**Town of Surfside
SPECIAL PLANNING & ZONING BOARD
AGENDA**

February 11, 2021 – 6:00 p.m.

To: Planning and Zoning Board
Thru: Andrew Hyatt, Town Manager
From: Walter Keller, PE, AICP., Town Consultant Planner
Marlin Engineering, Inc.
CC: Jason Greene, Assistant Town Manager
Lillian Arango, Town Attorney
Date February 1, 2021
RE: 9133 – 9149 Collins Avenue – Seaway Condo Acquisition LLC – Site Plan Amendment

SHEET NO.
A3.02

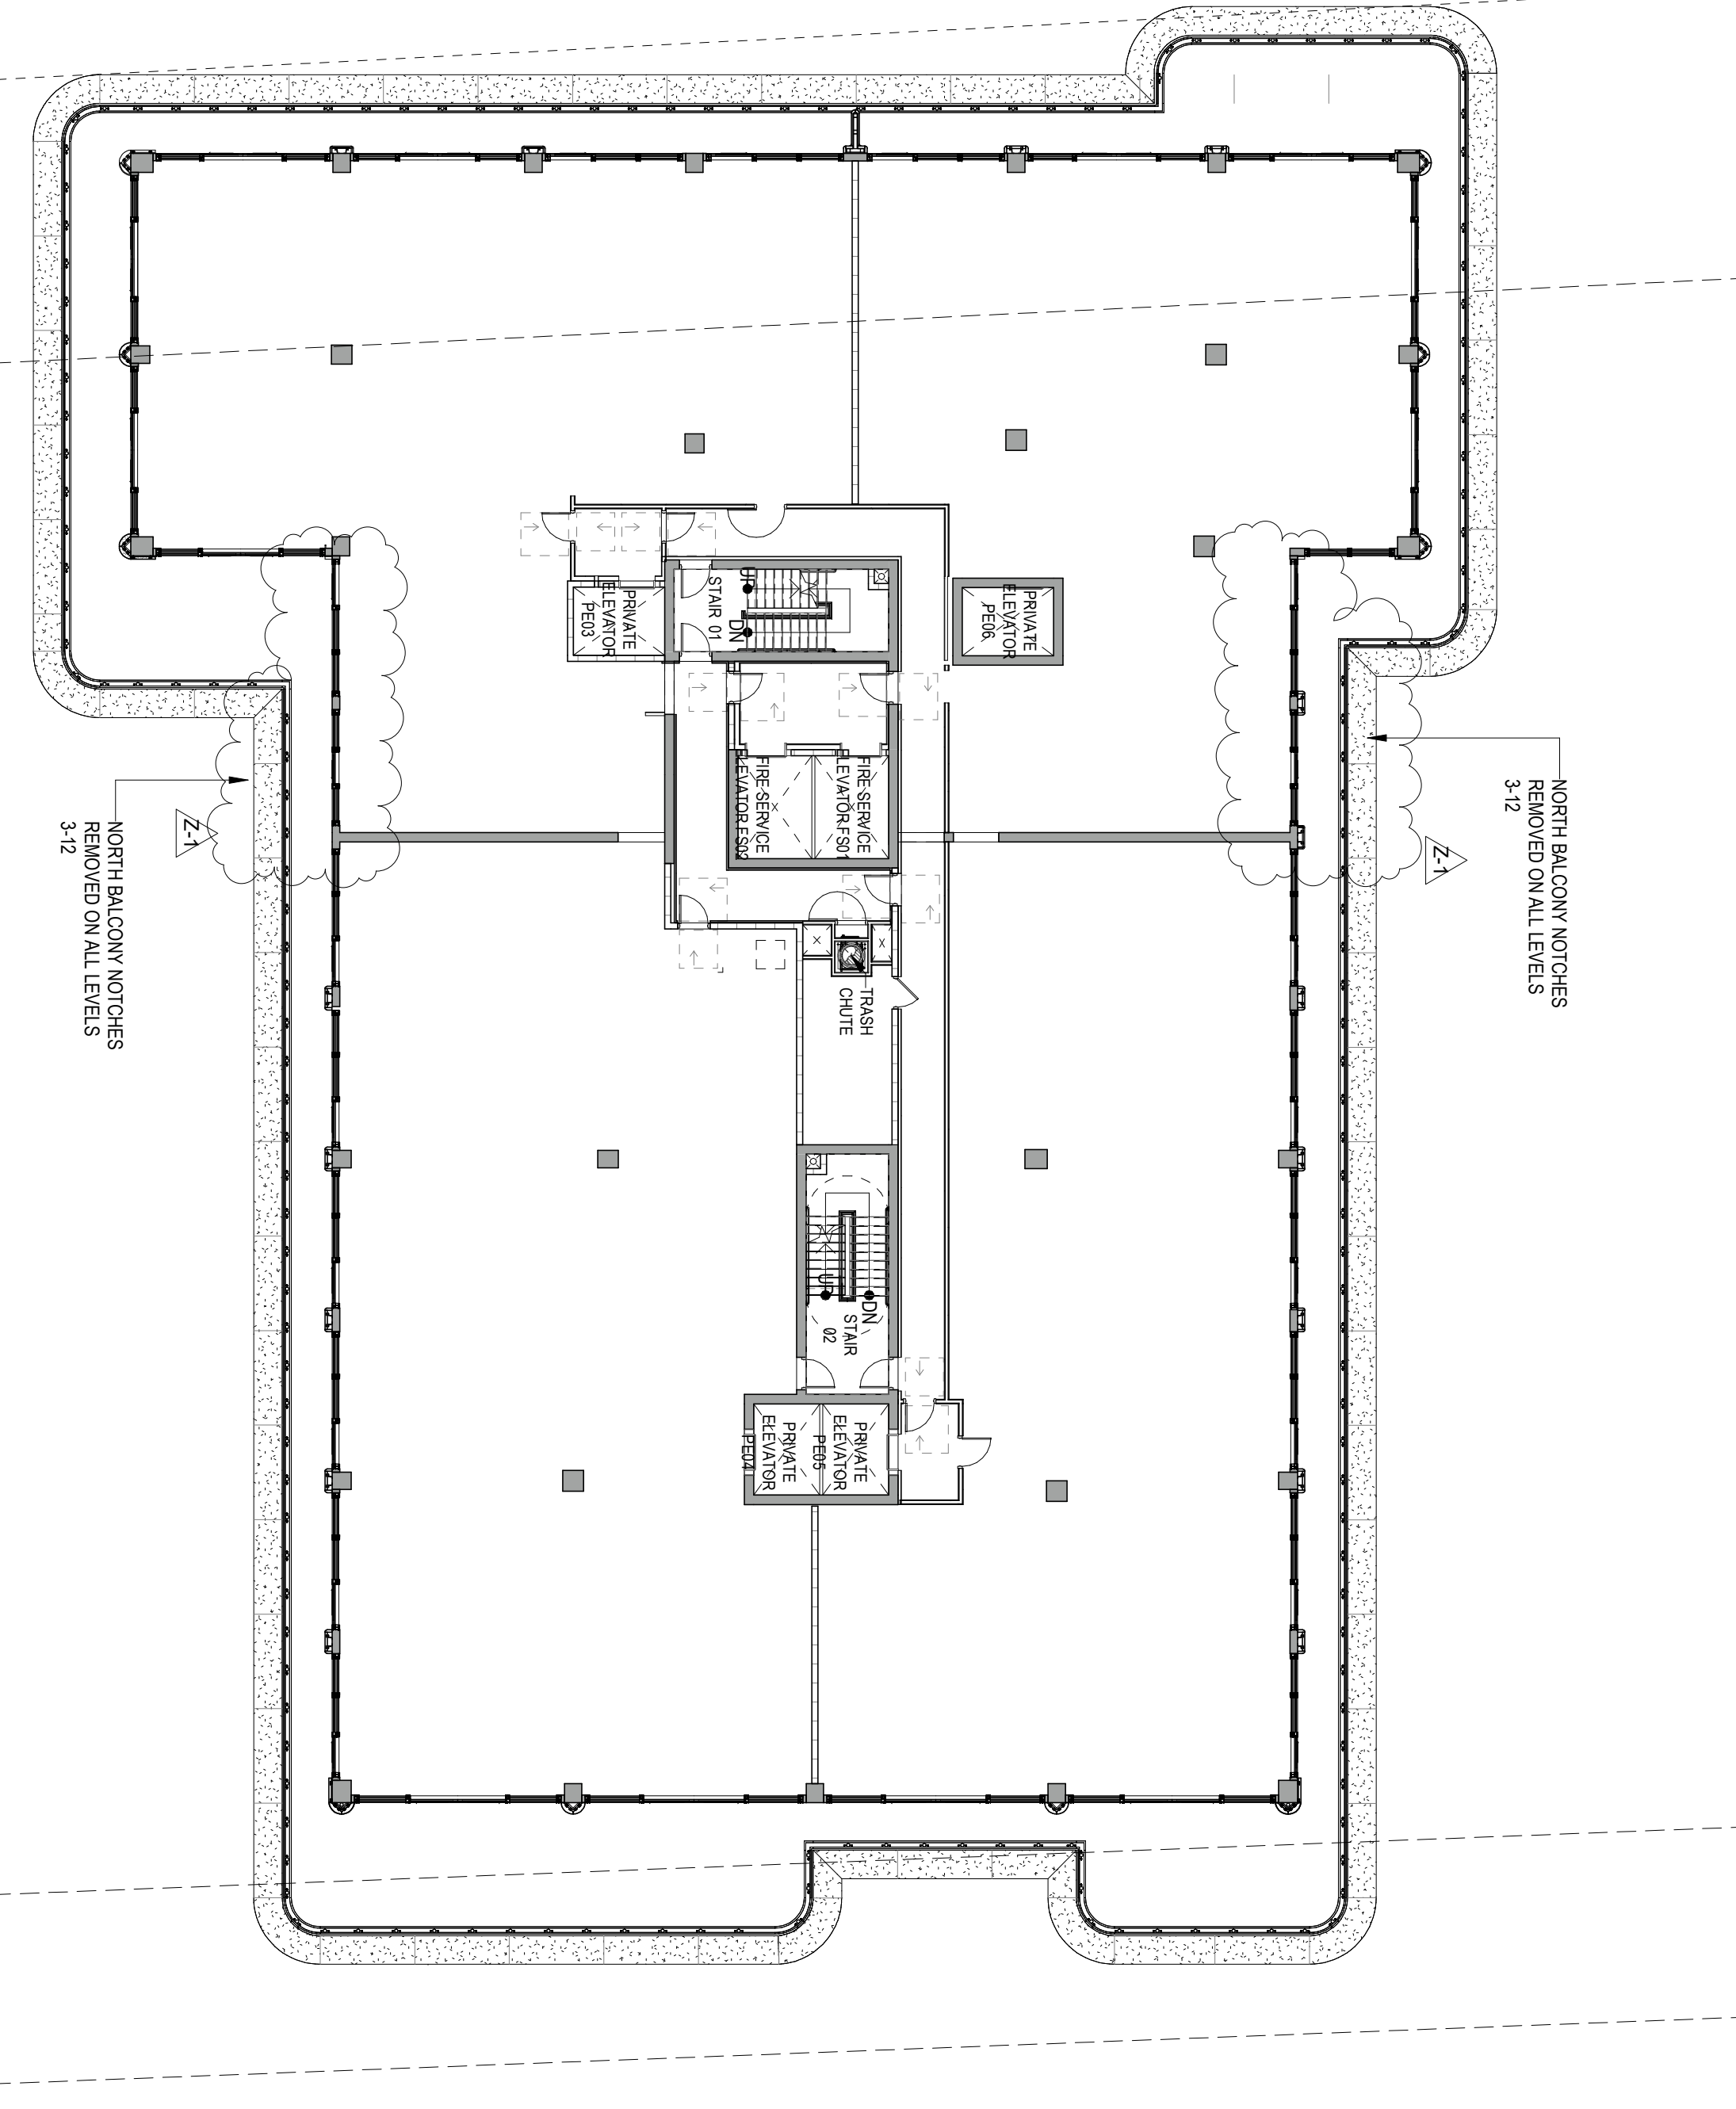
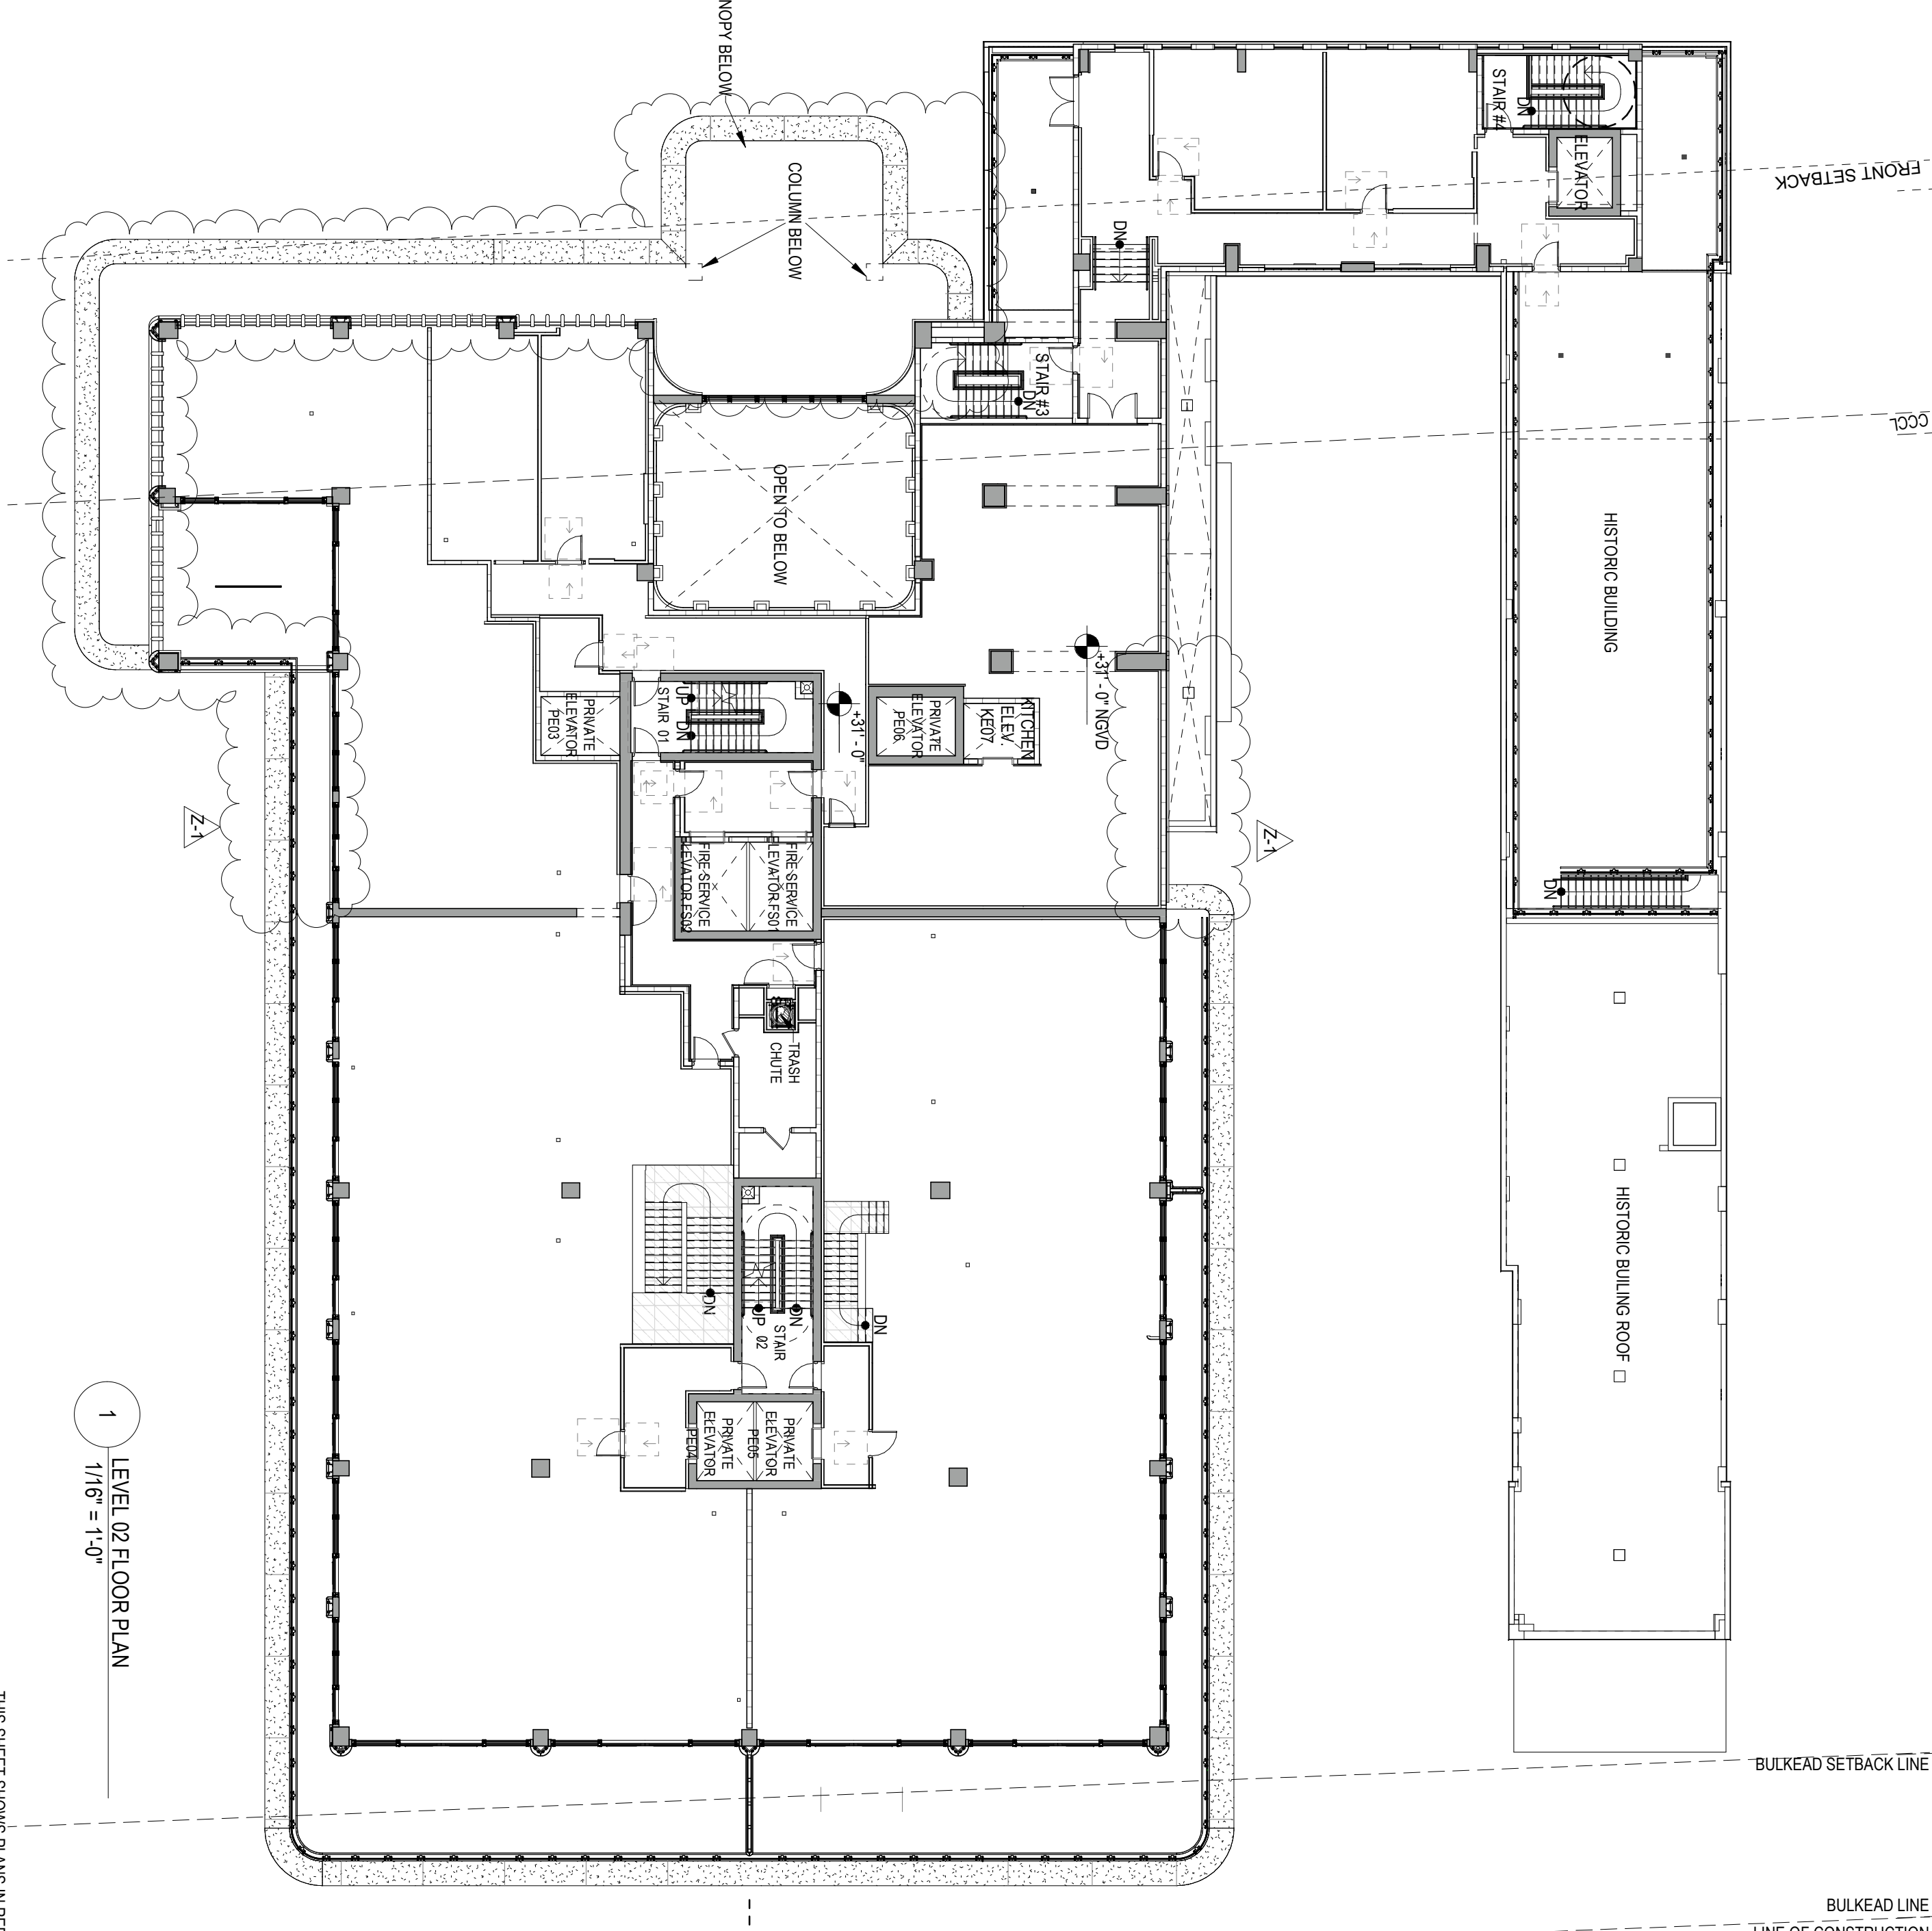
As shown on Amended Sheets A0.00, A1.03, A1.04, A1.05, A2.00, A3.00, A3.02, A4.01, and A4.02, Applicant’s new architect of record, ODP Architects, has proposed minor exterior design enhancements that include removing “notches” in balcony design on the north and south sides of levels 2 through 12; extending a balcony on the 11th level to make the design consistent with lower typical floors; and adding decorative stone louvers and balconies on the 2nd and 3rd levels to provide privacy for unit owners and hotel units. No amendments are proposed to the exterior of the historic Seaway building.
